**ADDENDUM NO. 2
TO THE CONTRACT PROVISIONS AND CONTRACT PLANS**

**CITY OF CHELAN
LIFT STATION IMPROVEMENTS - REBID**

G&O #18041

ISSUED THIS DATE: TUESDAY, DECEMBER 4, 2018

CITY OF CHELAN
 CHELAN COUNTY WASHINGTON
LIFT STATION IMPROVEMENTS - REBID
 SITE NO. 1 - LIFT STATION NO. 16
 PLAN AND SECTIONS

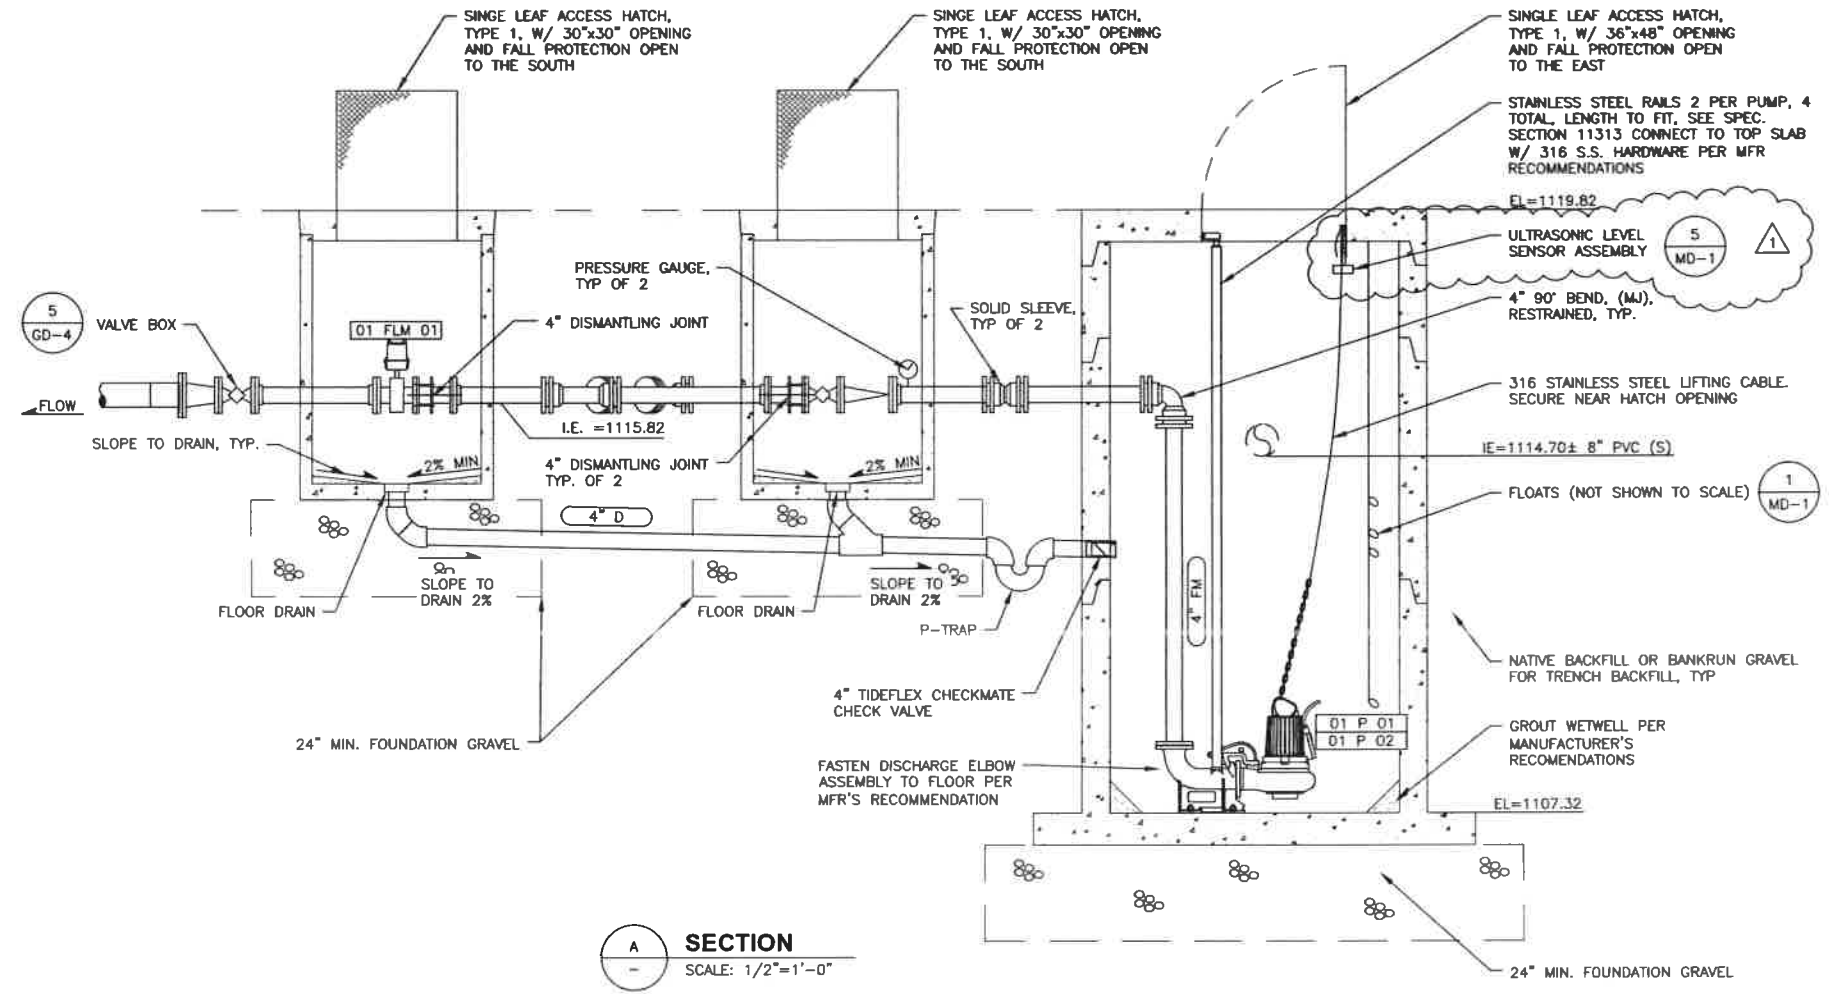
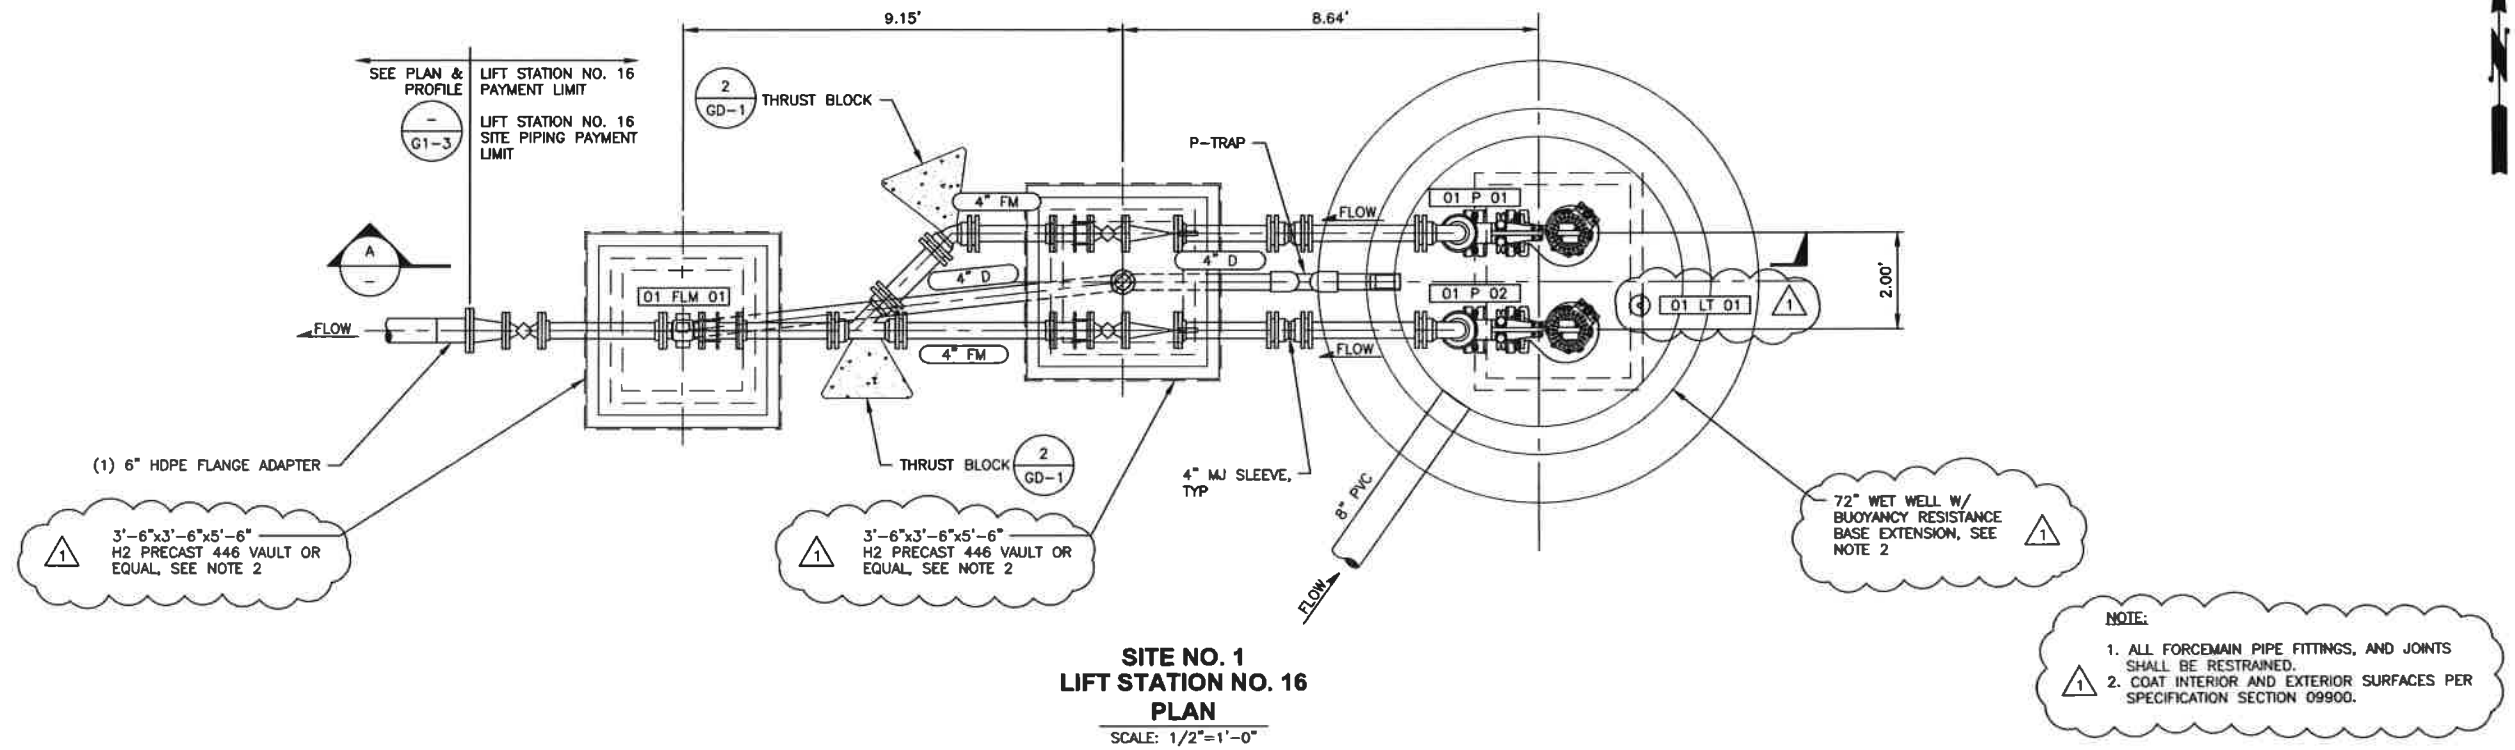
SHEET M1-1, SITE NO. 1 – LIFT STATION NO. 16 PLAN AND SECTIONS

DELETE the entire Sheet and **REPLACE** with the attached Sheet M1-1R.

NOTE:
 1. ALL FORCEMAIN PIPE FITTINGS, AND JOINTS SHALL BE RESTRAINED.
 2. COAT INTERIOR AND EXTERIOR SURFACES PER SPECIFICATION SECTION 09900.

1 SITE NO. 2 - LS NO. 10 PLAN
SCALE: 1/2"=1'-0"

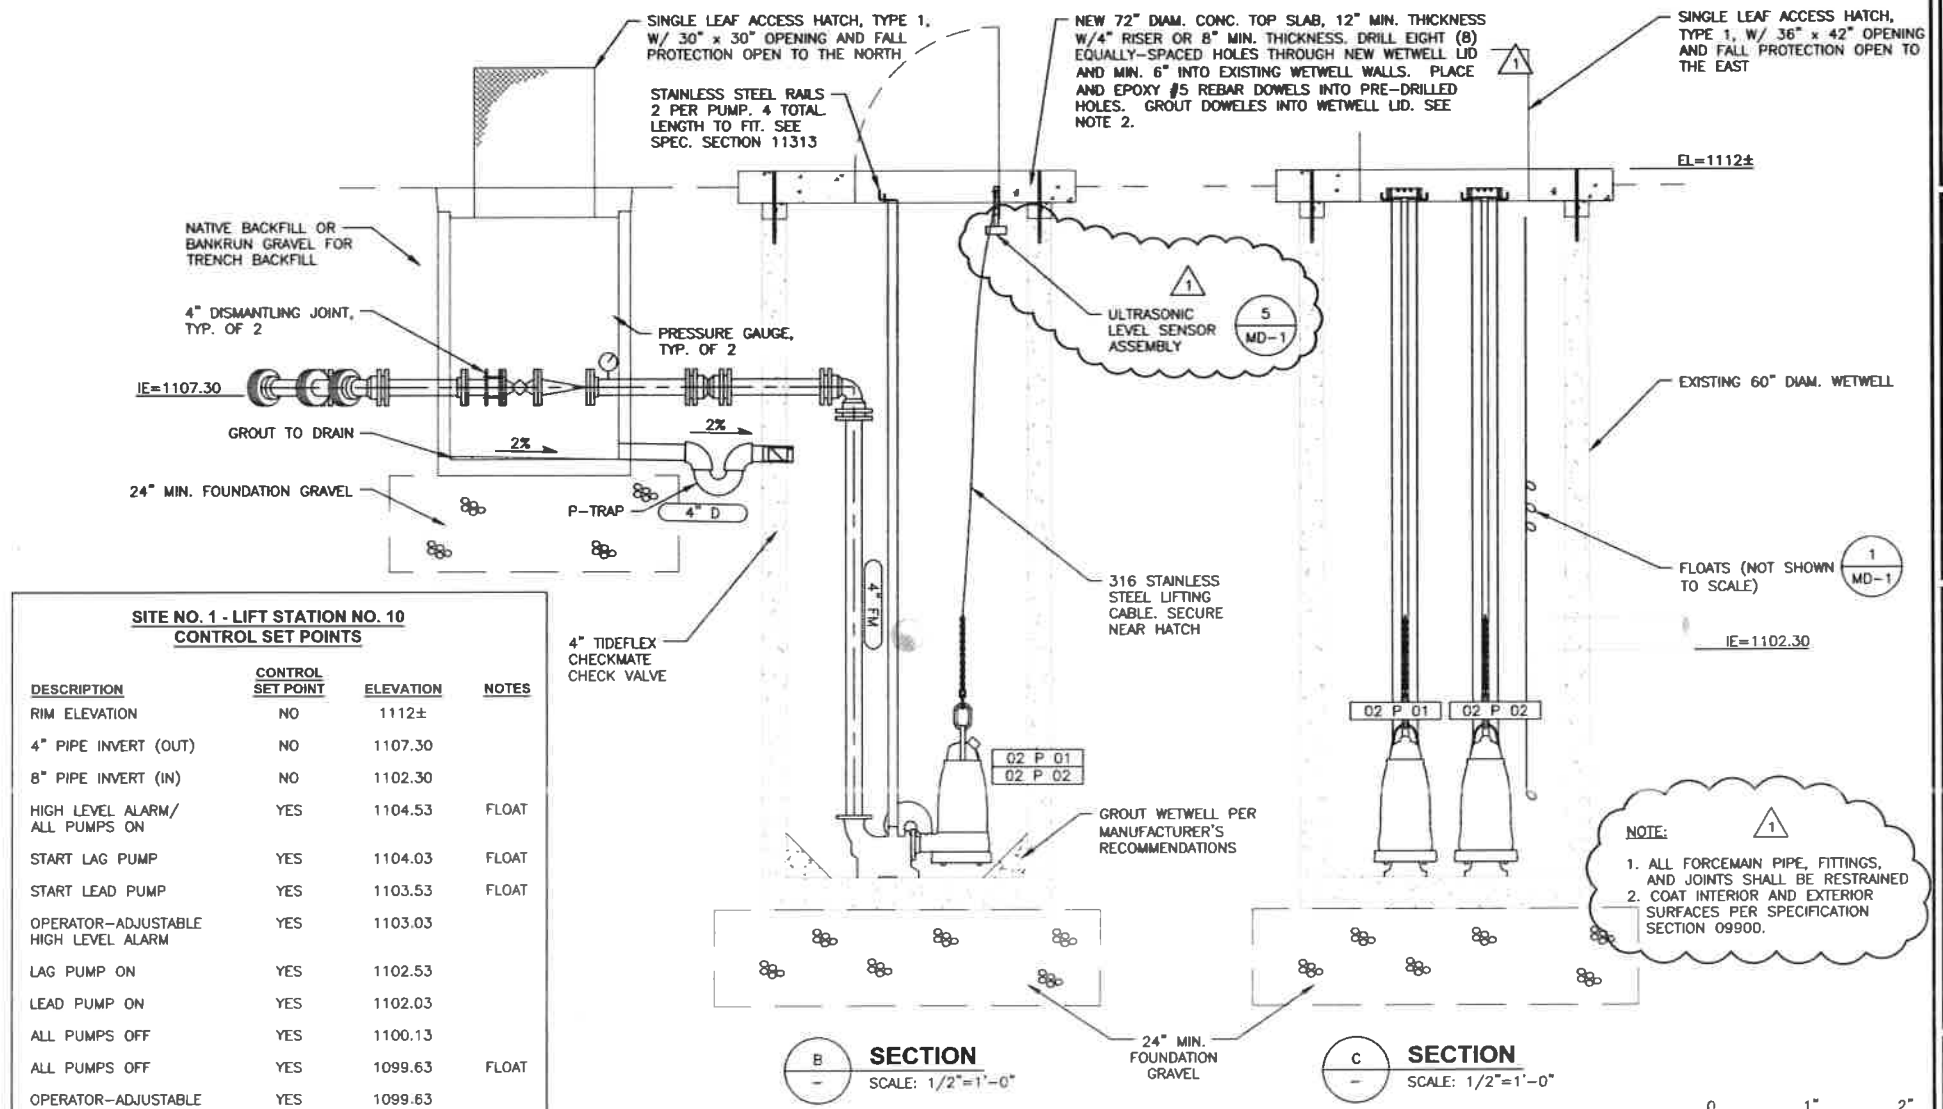
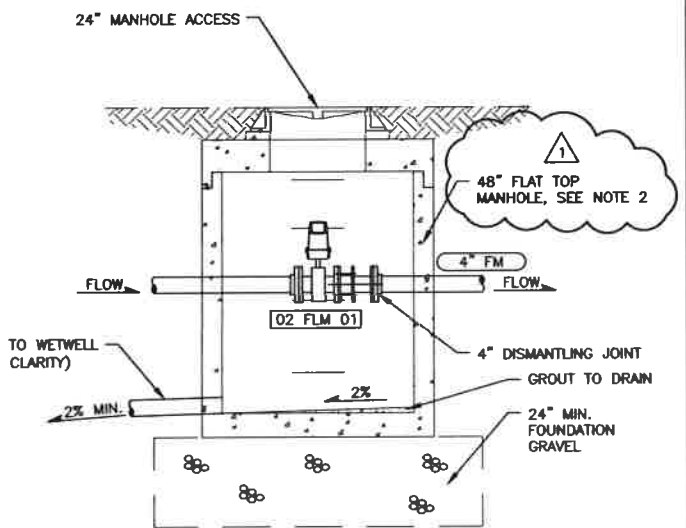
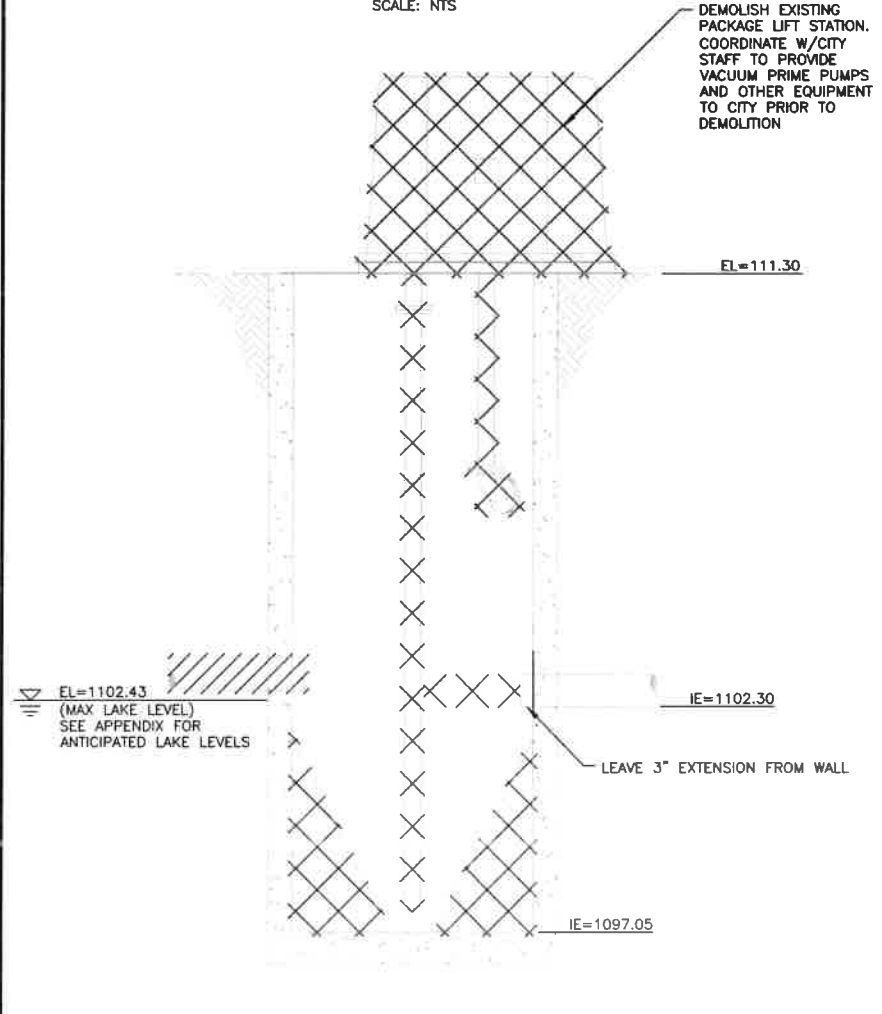
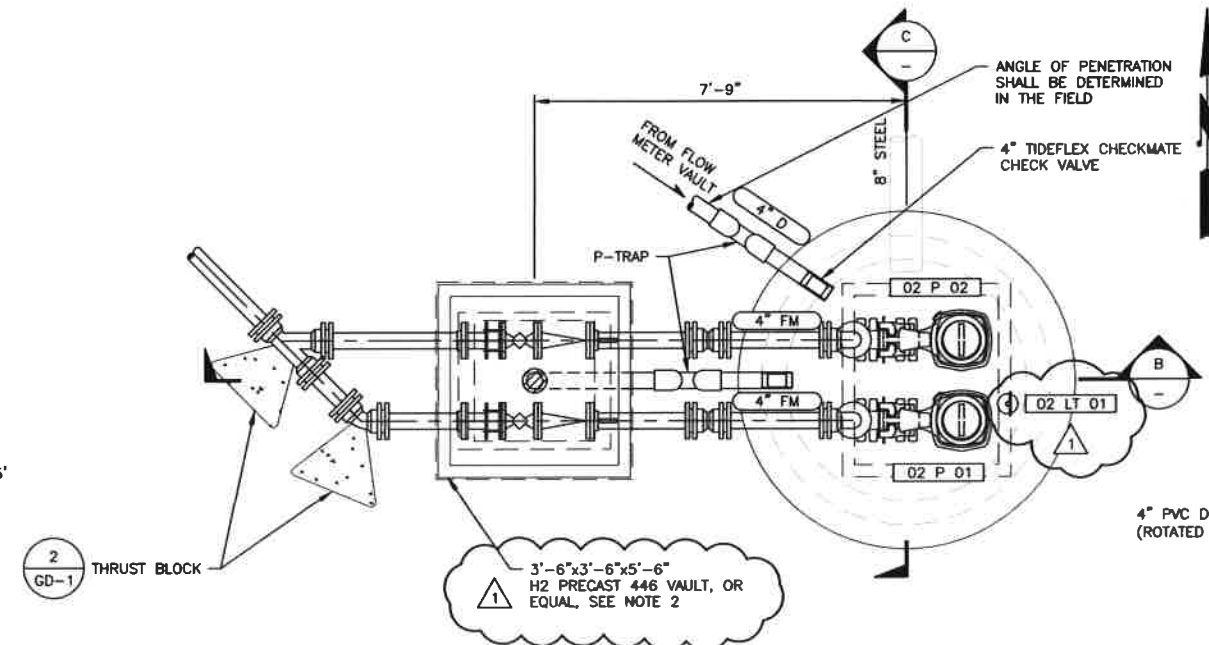
SHEET M2-1, SITE NO. 2 – LIFT STATION NO. 10 PLAN AND SECTIONS

DELETE the entire Sheet and **REPLACE** with the attached Sheet M2-1R.

1. ALL FORCEMAIN PIPE, FITTINGS, AND JOINTS SHALL BE RESTRAINED
2. COAT INTERIOR AND EXTERIOR SURFACES PER SPECIFICATION SECTION 09900.

5
TYP
ULTRASONIC LEVEL SENSOR ASSEMBLY
NOT TO SCALE

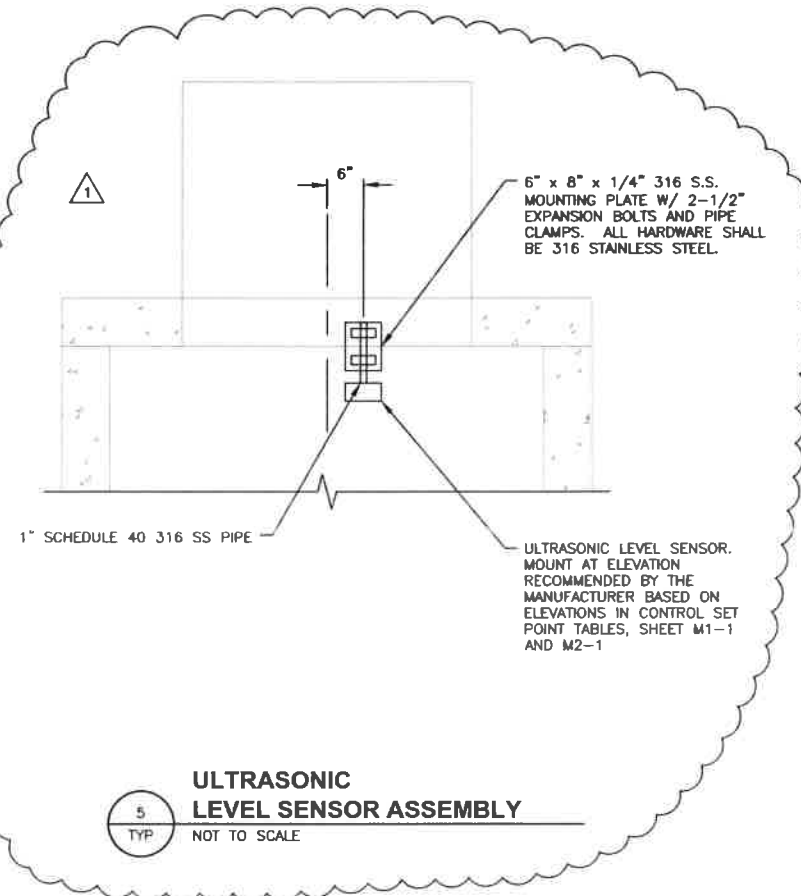
SHEET MD-1, MECHANICAL DETAILS

DELETE the entire Sheet and **REPLACE** with the attached Sheet MD-1R.

REVISE the pressure level transducer to be an ultrasonic level transducer. Revise the mounting to match the mounting detail added in this addendum.
